SUBJECT: Retransmittal of Responses to AP1000 DSER Open Items

AP1000 DESIGN CERTIFICATION REVIEW

Draft Safety Evaluation Report Open Item Response

DSER Open Item Number: 5.2.3-3 Revision 1

Figure 1 – Axial (top) and hoop (bottom) stresses on the DVI nozzle arising from an accident event in which the nozzle temperature is reduced from 550°F to 50°F in 30 seconds due to failure of the CMT isolation system.

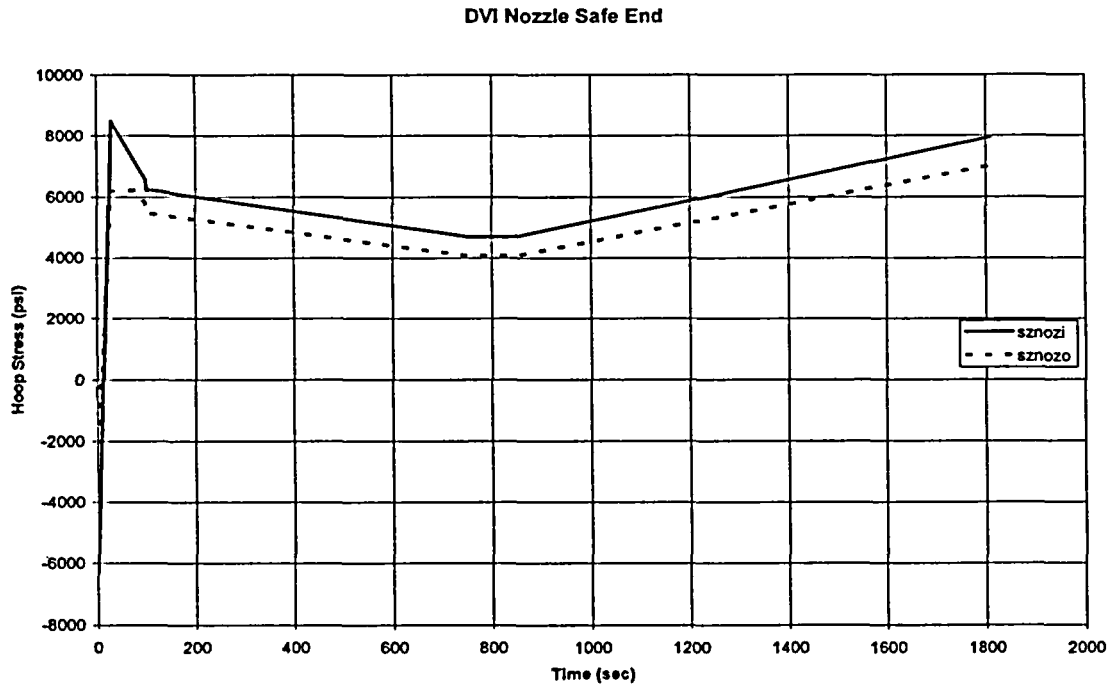
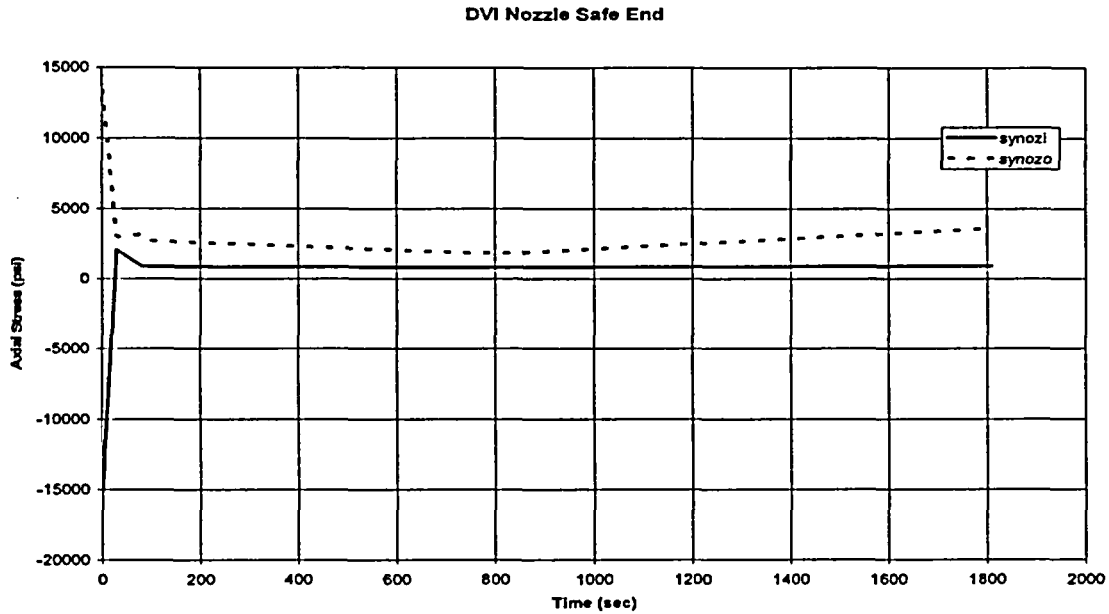
- a. Provide the H₂ concentration of the reactor coolant at normal plant operating conditions.
- b. The LTCP issue is loading rate sensitive. Please indicate what transients could lead to LTCP in reactor coolant pressure boundary welds in the AP1000 and provide the applicable loading rates for those transients. For the limiting transient or transients from that set, what temperature levels would the most susceptible bi-metallic welds reach? What bi-metallic welds in the reactor coolant system would experience the most significant cool down effect (i.e., maximum stress intensity)?

the CMT cools the safe-end weld from 550°F to 50°F in 30 seconds. This leads to a rapid spike in the stresses, both on the inside and on the outside of the nozzle. Figure 1 shows the results of the temperature and pressure transients on the axial (top plot) and hoop (bottom plot) stresses. The solid curves are of interest, since they are the stresses acting at the inside, wetted surface.

Figure 2

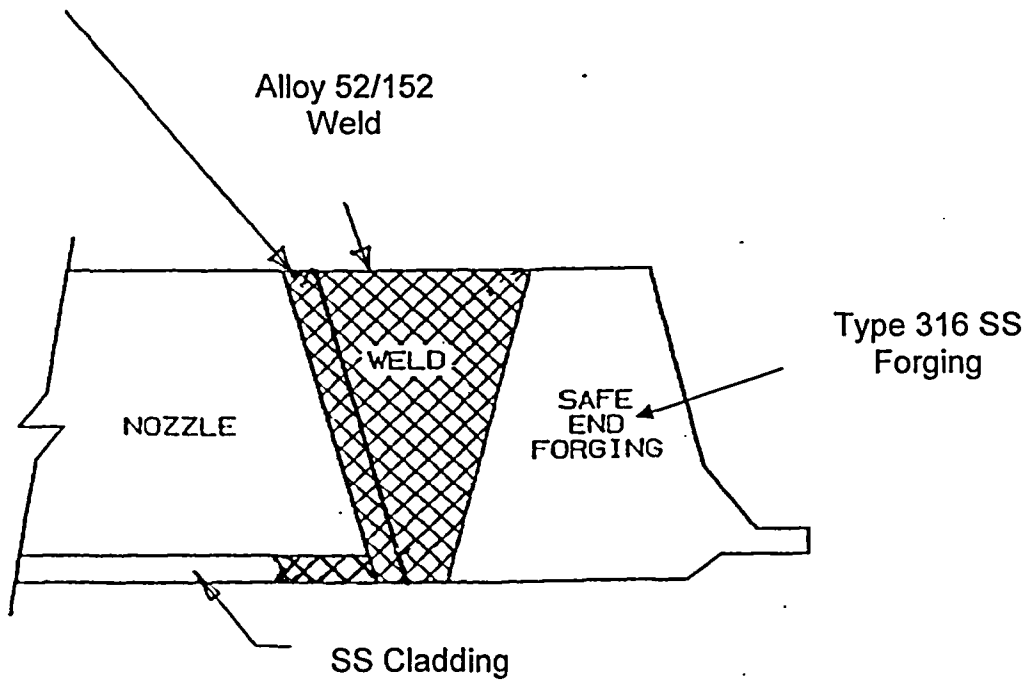
- c. Provide a schematic drawing of welds at these locations. For example, describe whether these welds would consist of Alloy 52 material through the entire wall or would consist of Alloy 52 in contact with the reactor coolant and Alloy 82 for the remainder of the wall thickness.

- c) Figure 2 provides a sketch of a typical nozzle safe-end butt weld. These welds are composed entirely of Alloy 52 (root and subsequent few passes) and Alloy 152 (later passes).

Figure 21.5-1.12 ADS-4 Liquid Discharge Comparison

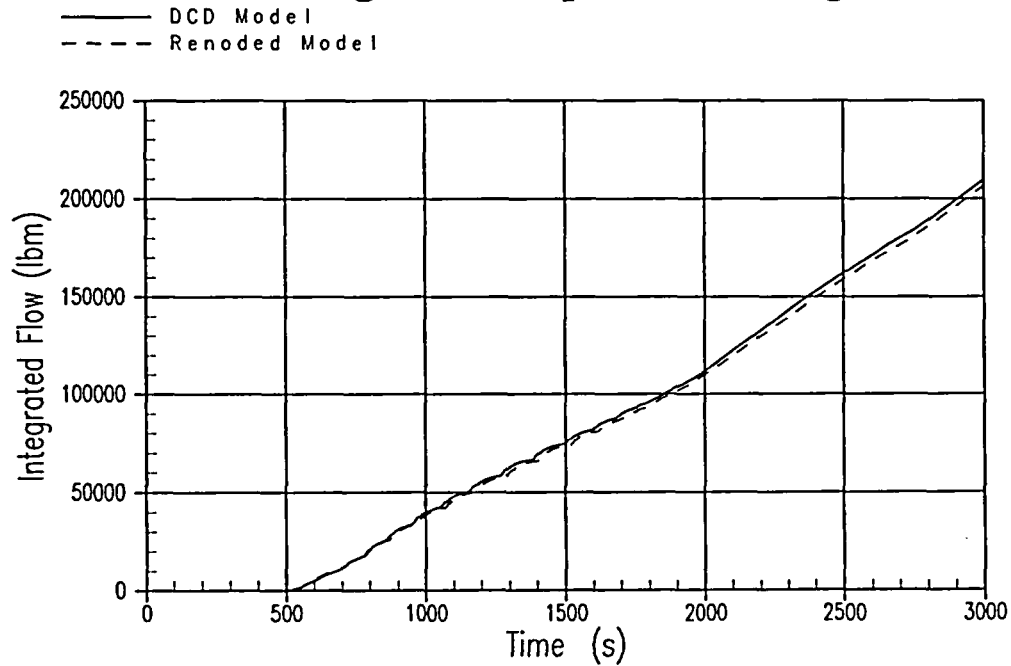
For the comparison of the integrated liquid discharge through ADS-4 between the base DCD case and the revised nodding model, Figure 21.5-1.12 on DSER OI 21.5-1P Page 11 has an inconsistency in that the heading states "ADS-4 Liquid Discharge Comparison" whereas the actual figure is for ADS-4 integrated vapor discharge.

Please clarify.

Figure 21.2.1-12 was intended to be a plot of ADS-4 Liquid Discharge Comparison. However the figure that was included was ADS-4 integrated vapor discharge as the Item states. The attached figure is the corrected Figure 21.5-1.12 that shows ADS-4 Liquid Discharge Comparison.

Figure 21.5-1.14 Downcomer Pressure Comparison

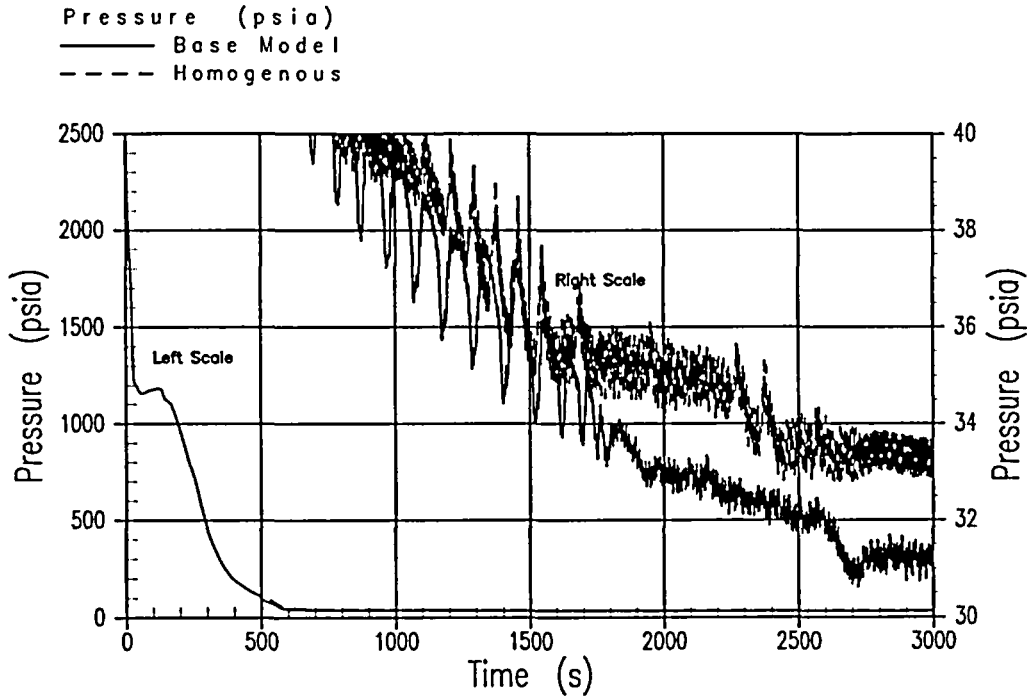
The text on DSER OI 21.5-1P Page 3 states that Figure 21.5-1.14 presents a comparison of the upper downcomer pressure between the base case and the sensitivity case, but the actual figure is for pressurizer pressure (except for the heading). The text also states that the pressurizer mixture level response (Figure 21.5-1.25) reflects the change in pressure response (Figure 21.5-1.14) observed in the model.

Clarify the discrepancy regarding Figure 21.5-1.14.

Figure 21.5-1.14 was intended to show the upper downcomer pressure between the base case and the sensitivity case, but the actual figure is incorrect as stated in Item 17 above. The attached figure provides the corrected Figure 21.5-1.14. The plot of Pressurizer pressure is also provided as 21.5-1.26 and the text should refer to this figure for pressurizer pressure. No update to the previous response is intended.

Figure 28-3

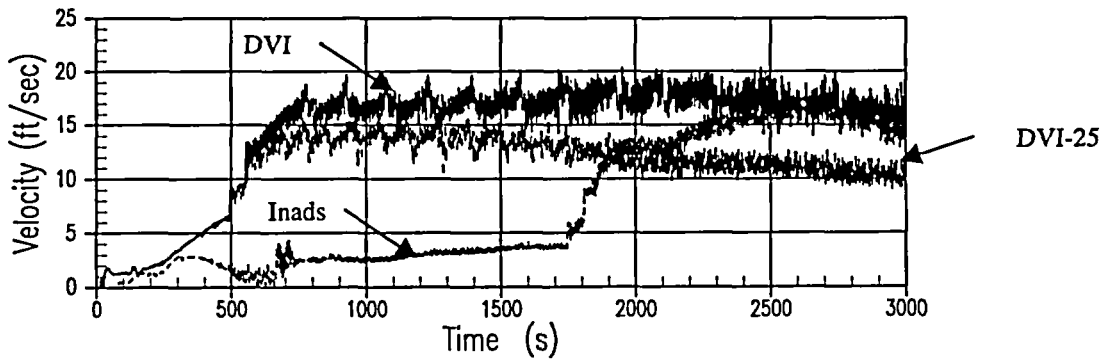
Westinghouse's response to the staff's comments ('Item 28') on the selection of the APEX test matrix and NOTRUMP simulations is insufficient. Westinghouse merely provided comparisons of the core collapsed liquid levels of the NOTRUMP simulations of the APEX-600 tests of DEDVI and inadvertent ADS, and the NOTRUMP simulation of APEX-1000 DEDVI tests. Westinghouse concluded that this provides confidence that the NOTRUMP analysis of the AP1000 SBLOCA spectrum, including the inadvertent ADS case, are adequate.

Westinghouse should provide comparisons of the relevant dimensionless groups for the inadvertent ADS case and DEDVI case to demonstrate the NOTRUMP simulation is adequate in identifying the limiting break for AP1000.

Figure 28-3 shows the NOTRUMP calculated core exit vapor velocity for the AP1000 DEDVI event at two containment pressures (25 psia and 14.7 psia) and for the Inadvertent ADS 1-3 event at 14.7 psia containment pressure. The vapor velocity is higher for the DEDVI case at 14.7 psia than for the Inadvertent ADS 1-3 at 14.7 psia. Since the 14.7 psia containment pressure applies in the APEX-1000 test facility, this is another indication that the DEDVI tests performed in APEX-1000 are somewhat more limiting from the viewpoint of vapor velocity and its effects on entrainment and ADS4 venting.

Revision 1 of this response provided the superficial gas velocity at the core exit (Figure 28-3) as predicted by NOTRUMP for the AP1000 DEDVI and Inadvertent ADS cases. This comparison shows that for a given backpressure, the DEDVI case is somewhat more limiting than the Inadvertent ADS case. The APEX-600 test data also confirms that higher core voiding is experienced in the DEDVI case.

Figure F-12 ADS-4 Liquid Discharge Comparison

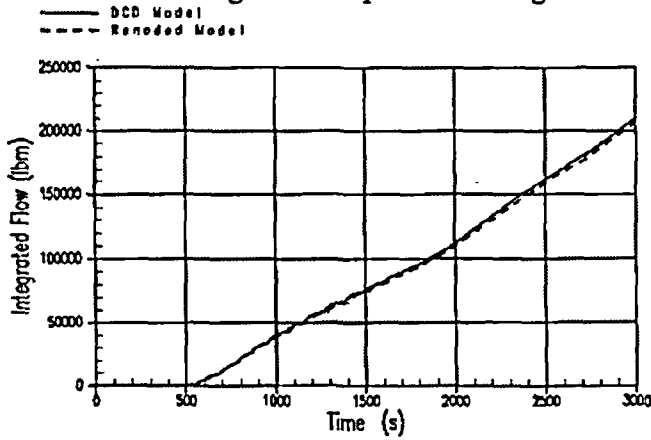
Correct Figure F-12 (i.e., Figure 21.5-1.12) for ADS-4 Liquid Discharge Comparison.

Figure F-12 and Figure F-13 present the ADS-4 Integrated liquid and vapor discharges for the two cases respectively. Again, the differences between these two cases are considered to be negligible.

Figure F-14 Downcomer Pressure Comparison

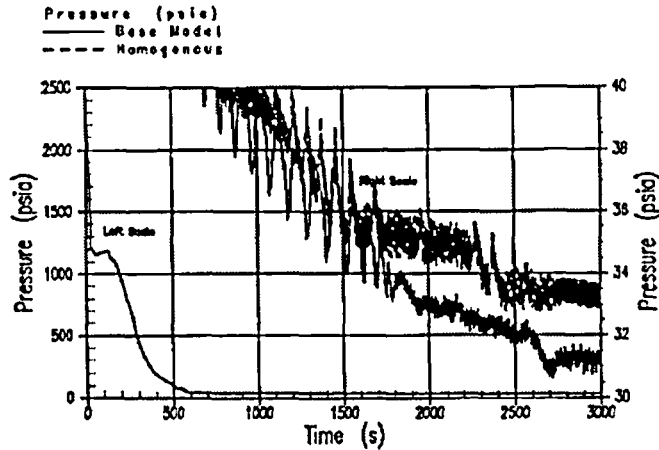
Correct text and Figure F-14 (i.e., Figure 21.5-1.14) to show Downcomer Pressure Comparison.

Figure F-14 presents a comparison of the upper downcomer pressure between the base and sensitivity cases. As can be seen, the sensitivity case results in higher upper downcomer pressure and subsequently results in delayed IRWST injection (Figure F-15). This can also be observed in the intact DVI line flow, which comprises all intact injection flow components (i.e. Accumulator, CMT and IRWST) per Figure F-16. As expected, the initial ADS-4 liquid discharge is much higher (Figure F-17) until the inventory which resided in the upper plenum and hot leg regions was depleted (Figure F-18). The net effect is a decrease in the ADS-4 vapor discharge rate (Figure F-19) and subsequently higher RCS pressures.
